RE: Docket No. 04008904 1800, Response to September 2, 1988 NRC  
Comments

INTERA'S RESPONSE TO NRC COMMENTS OF SEPTEMBER 2, 1988

Figure 1

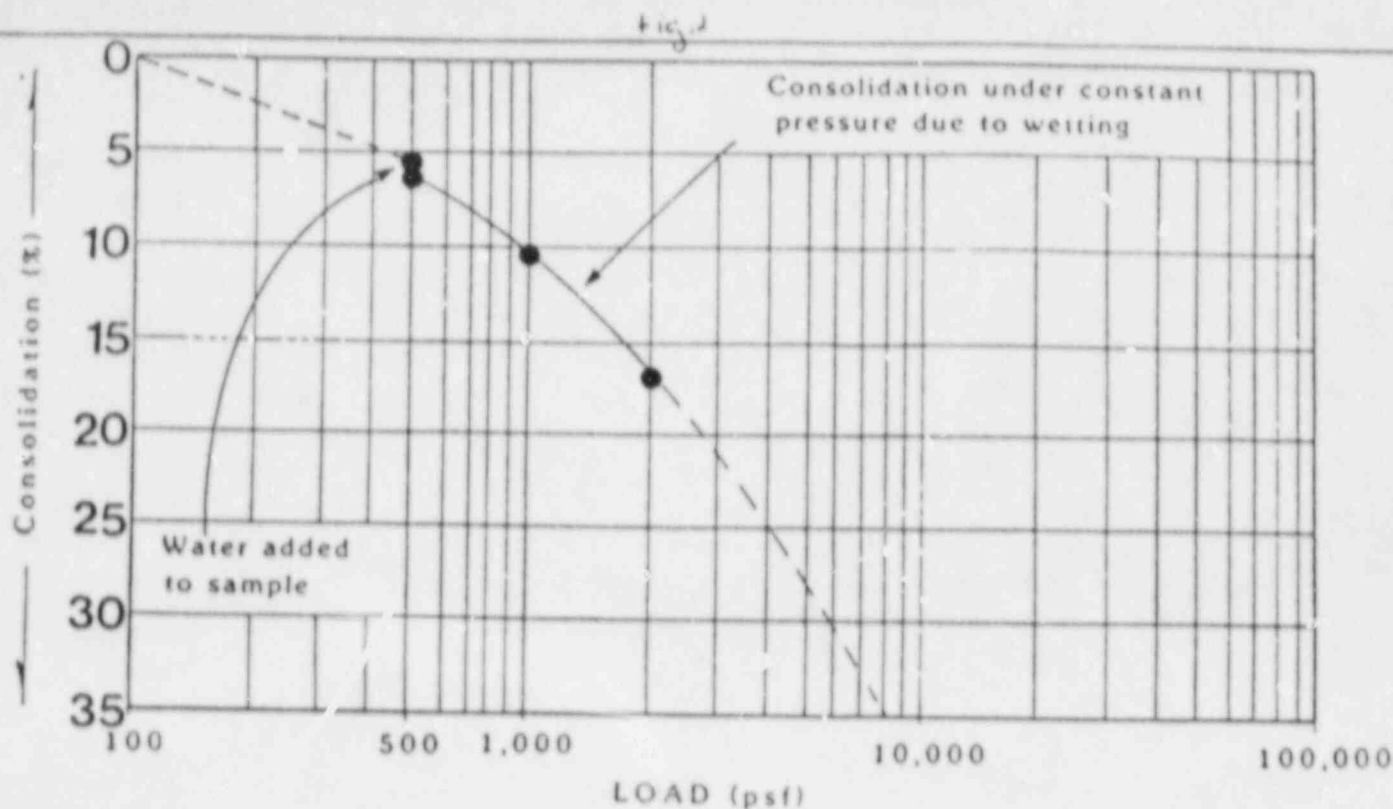
- a. Core Samples were reportedly taken from the deepest portion of the pond. As this program is the basis for the settlement calculation, the complete exploration program should be submitted including a location map, boring logs, and any associated testing.

Two samples of bottom slimes were taken from the central, and what was determined to be deepest, portion of the tailings pond (see attached map). Samples were taken by driving 2" PVC pipe through the bottom sediments into the underlying clay far enough to form a clay plug in the bottom of the PVC pipe. The PVC pipe was then extracted, shortened to the core length, capped at both ends, and delivered upright to the laboratory for testing. The samples were tested for one dimensional consolidation properties by Fox and Associates of New Mexico, Inc., of Albuquerque N.M. These test results are attached. The semi-liquid nature of the material made testing very difficult and it actually extruded from the testing apparatus during testing. The results are considered to be of marginal value.
